Change No. 18
License No. DPR-16

LICENSE NO. DPR-16

CHANGE NO. 18 TO TECHNICAL SPECIFICATIONS

DOCKET NO. 50-219

FIGURE 3.10.1

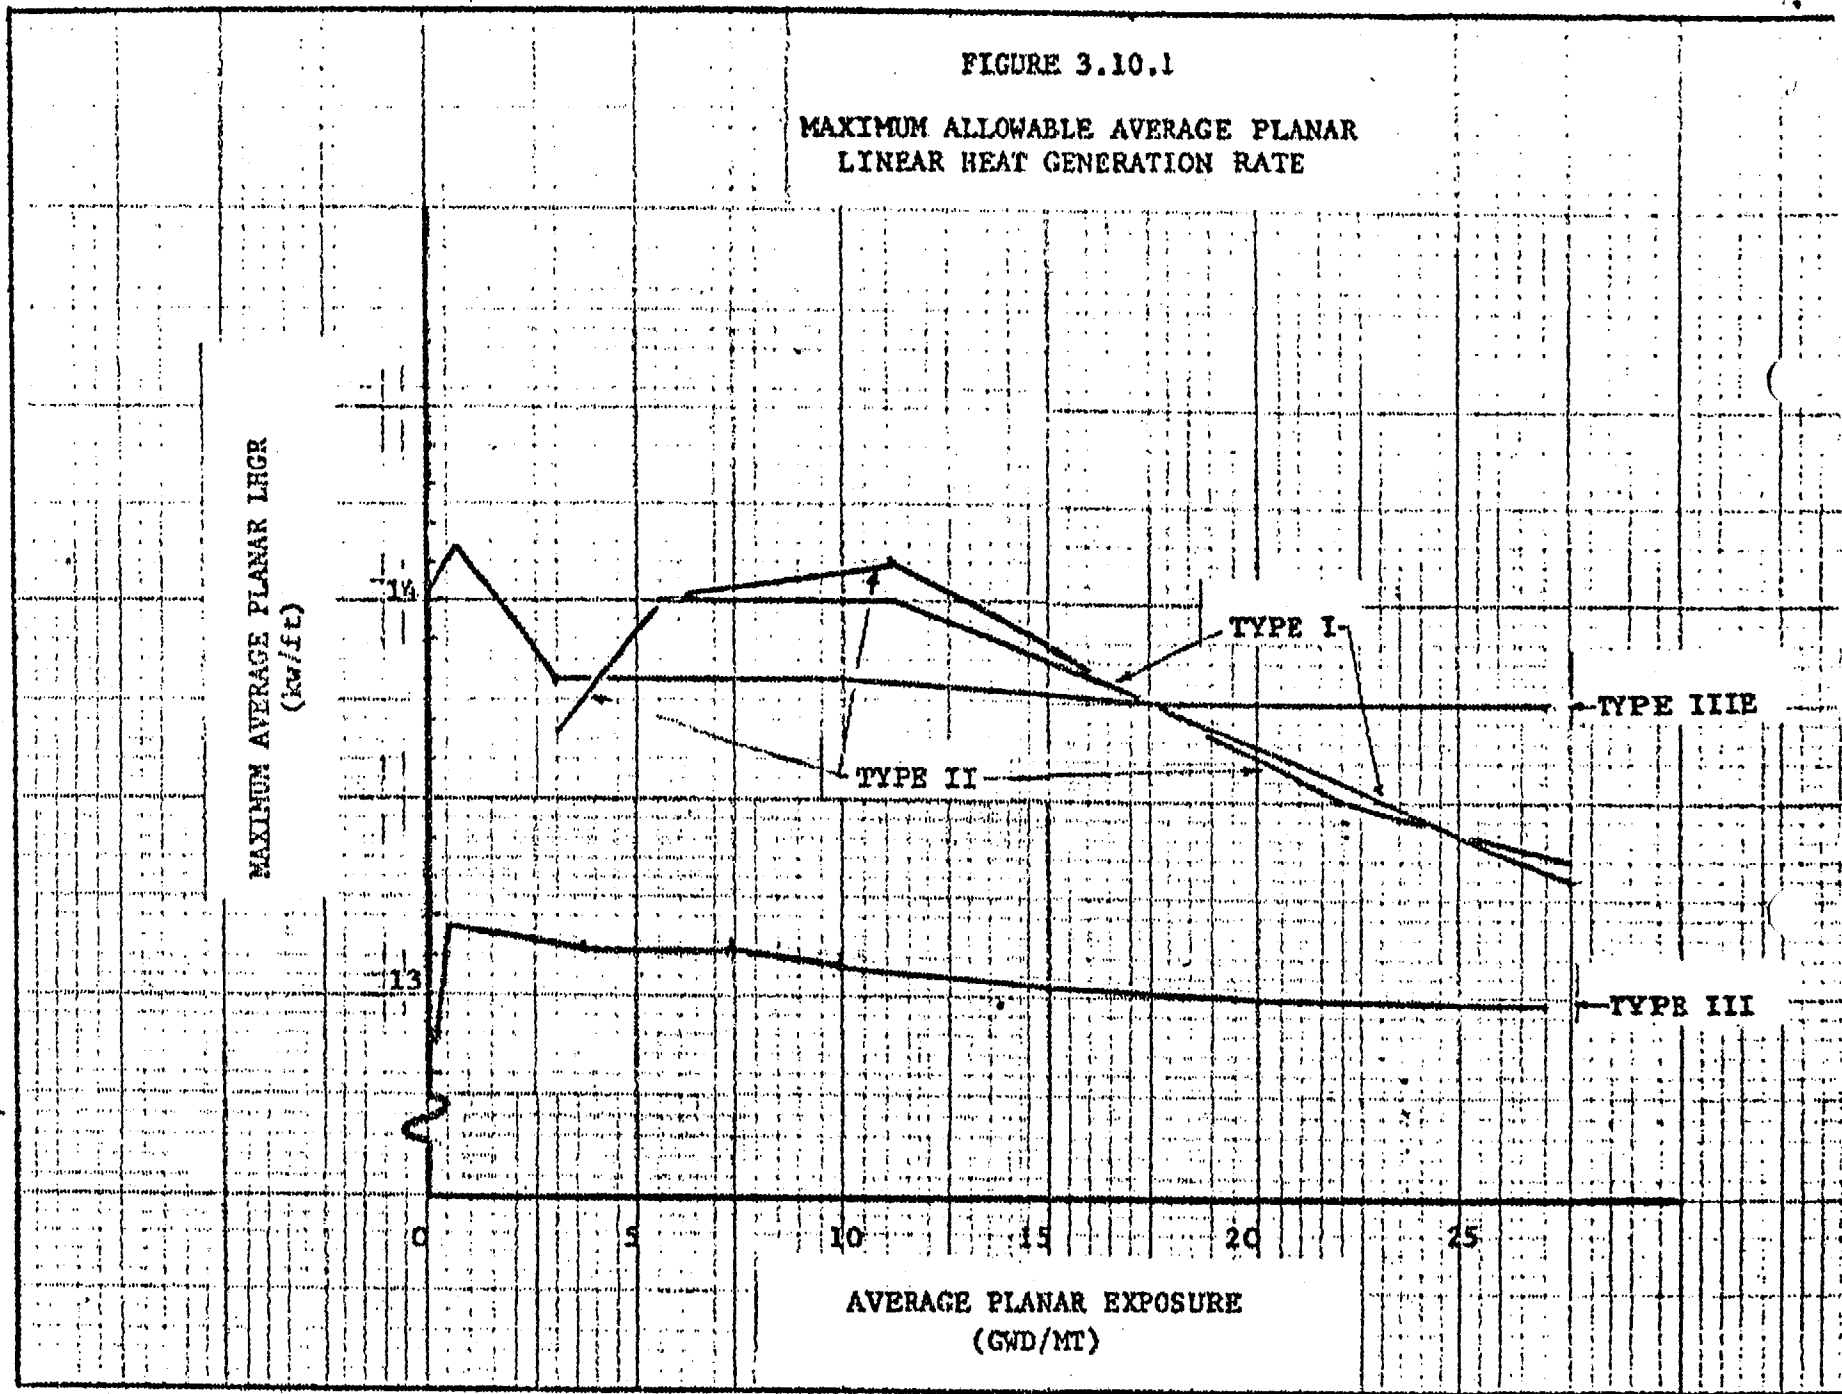
Your letter dated December 14, 1973, proposed changes to the Technical Specifications of Facility License No. DPR-16 for the Oyster Creek reactor that would increase the maximum average planar linear heat generation rate (MAPLHGR). These changes in the MAPLHGR are the result of changes in the fuel densification model by the General Electric Company as reported in NEDO-20181, "GEGAP III A Model for Prediction of Pellet-Clad Thermal Conductance in BWR Fuel Rods", dated November 1973 and its supplement NEDC-20181 Supplement 1 (Proprietary) dated November 1973 and by EXXON Nuclear as reported in XN-174, "Technical Report on Densification of EXXON Nuclear BWR Fuel", dated November 1973. Modifications to the proposed models were made by the Regulatory staff and transmitted by our letters to you dated December 5 and December 13, 1973, respectively.

The changes in the fuel densification models provide for an exposure dependent gap conductance and time-dependent fuel densification. The Regulatory staff evaluation of these changes is reported in "Supplement 1 to the Technical Report on Densification of General Electric Reactor Fuels" dated December 14, 1973, and "Technical Report on Densification of EXXON Nuclear BWR Fuels, Supplement 1" dated December 17, 1973, and our Safety Evaluations dated December 14, 1973, for the Oyster Creek reactor which were provided to you by our letters of December 14 and December 21, 1973.

1. Replace Figure 3.10.1 on page 3.10-4, Change No. 17, with the attached Figure 3.10-1, page 3.10-4, Change No. 18.
2. Replace Bases, pages 3.10-2 and 3.10-3, Changes No. 16 and 17, with the attached pages 3.10-2 and 3.10-3, Change No. 18.

The maximum average planar LHGR shown in Figure 3.10.1 for Type I and II fuel is the result of LOCA analyses using values of gap conductance calculated per GEGAP III (G.E. Topical Report, NEDO-20181, "A Model for the Prediction of Pellet Cladding Thermal Conductance in BWR Fuel Rods") with AEC modifications ("Modified G.E. Model for Fuel Densification", December 5, 1973). The Type I curve is the same as the curve labeled "Ω" (Omega) on Figure 5-A of a report attached to a letter dated December 12, 1973, to the AEC from General Electric Company. The Type II curve is the same as the curve labeled "Ω" (Omega) on Figure 6-A of the same report. These calculations were made to determine the effect of densification on PCT following a postulated LOCA and include the results of detailed heatup calculations for the PCT at exposures up to 25,000 MWD/MT.

The maximum average planar LHGR shown in Figure 3.10.1 for Type III and IIIIE fuel are the result of calculations presented in Supplement No. 1 to the Exxon Nuclear Company Topical Report, XN-174, "Densification Effects on Nuclear Boiling Water Reactor Fuel", December 1973. These calculations were made to determine the effect of fuel densification on PCT following a postulated LOCA and include the results of detailed heatup calculations for the PCT to maximum planar exposures of 25,000 MWD/MT.
